**Section 36 Application
Stakeholder Comment Clarifications**

Llŷr Floating Wind Limited

P11-LYR-3.4.3-PAP-Rev 04 Marine Licence Application Clarifications 2

Gap Analysis - CAS-01352-L3N2P8 - Llŷr 1 Floating Offshore Wind Demonstration Project

Figure 1: Comparison of ZTV of Project Llyr at 325.5m and 300m tip heights

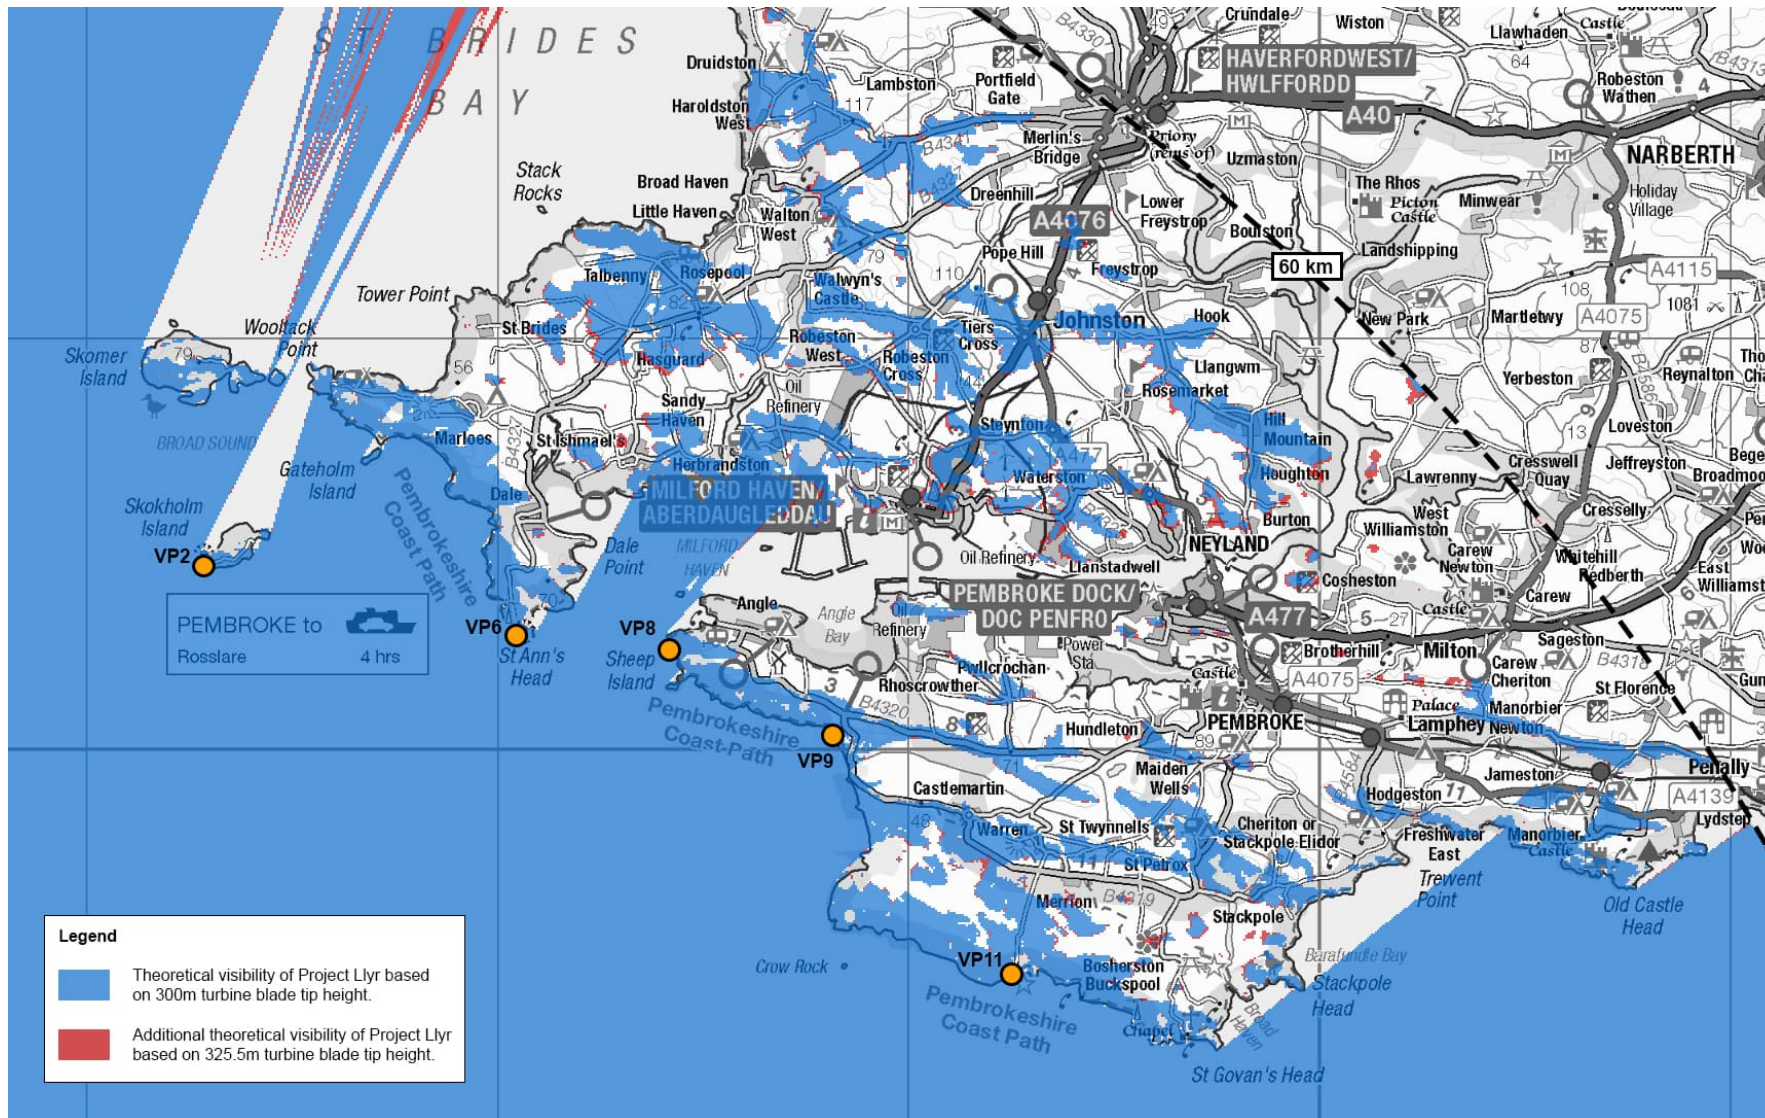
3.2	Designated Landscapes	<p>Whilst NRW A welcome the commitment to reduce the turbine blade tip height from 325.5m to 300m (above Highest Astronomical Tide), NRW A considers it would still be inside within the low magnitude of effect buffer identified for turbines of this height. As such, NRW A have advised that a reduction in blade tip height to 270m would reduce impacts within the Pembrokeshire Coastal National Park (PCNP) and likely to an acceptable level.</p> <p>Whilst it is noted that the Pembrokeshire Coastal National Park Authority (PCNPA) has removed their objection to the development as a result of further information, the PCNPA maintains concern regarding the outcomes of the Seascape, Landscape and Visual Impact Assessment. The PCNPA agrees with NRW A that reducing the blade tip height to 270m would reduce the landscape and visual impacts on the PCNP and would result in less significant effects for the PCNP.</p> <p>NRW A and the PCNPA have requested an updated Seascape and Landscape Visual Impact Assessment and photomontages to be able to conclude that the impacts on the PCNP would be reduced to an acceptable level.</p> <p>The PCNPA has also requested that a landscape and biodiversity enhancement scheme is implemented to secure compensation for the residual impact as a whole on the PCNP.</p>	<p>A technical note on the effect on the SLVIA by reducing the tip height from 325.5m to 300m, a technical report from Aecom has been provided. The project stands by its original technical assessment detailed within the Environment Statement that turbines with a tip height of 325.5m are acceptable and will not result in a significant impact.</p> <p>The technical note presents evidence in the form of additional Zone of Theoretical Visibility (ZTV) figures and wireline visualisations comparing 270m and 300m turbines for Llŷr Floating Wind Farm. The evidence supports the conclusions that due to distance and based on the ZTVs and the wirelines in Appendix A, there is no discernible difference in landscape and visual effects from Llŷr Floating Wind Farm turbines of 300m or 270m.</p> <p>It should also be noted that from a technical point of view, 300m is the minimum height achievable to ensure commercial scale turbine technology (up to 18 MW) whilst maintaining the necessary financial margins and turbine technical demonstration parameters needed to maintain the viability of the T&D project.</p> <p>A landscape enhancement scheme has been agreed with the PCNPA and NRW(A). This agreement is being drafted as a Section 106 agreement for signature.</p>

- 2.9 Reference to Figure 1: Comparison of ZTV of Project Llŷr at 325.5 and 300m tip heights shows areas shaded blue in which 300m turbines would theoretically be visible, the red shaded areas show the additional geographical extent of theoretical visibility of the 325.5m turbines. A simple visual comparison indicates that the differences in geographical extent are extremely limited such that although there is a reduced impact it would not translate into a reduction in magnitude and hence significance of effect.

- 4.1 AECOM confirm that in our view, the reduction of turbine height from 325.5m to 300m does not change any of the SLVIA outcomes relating to Project Llŷr. The primary reason for the conclusion is that the SLVIA assessed a “worst case” and although the reduction in height results in a theoretical reduction in visibility and magnitude of effect, at the distances concerned (typically over 35 km) there is no justifiable reduction in magnitude to a lower category, noting that effects at all viewpoints are small or negligible magnitude. We consider that this is evident from the ZTV (Figure 1) and wirelines comparing the 325,5 and 300m tip heights (Figures 3.1, 4.1, 5.1, 6.1 and 7.1) in Appendix A, showing the difference in height, which is barely perceptible at 35 km.
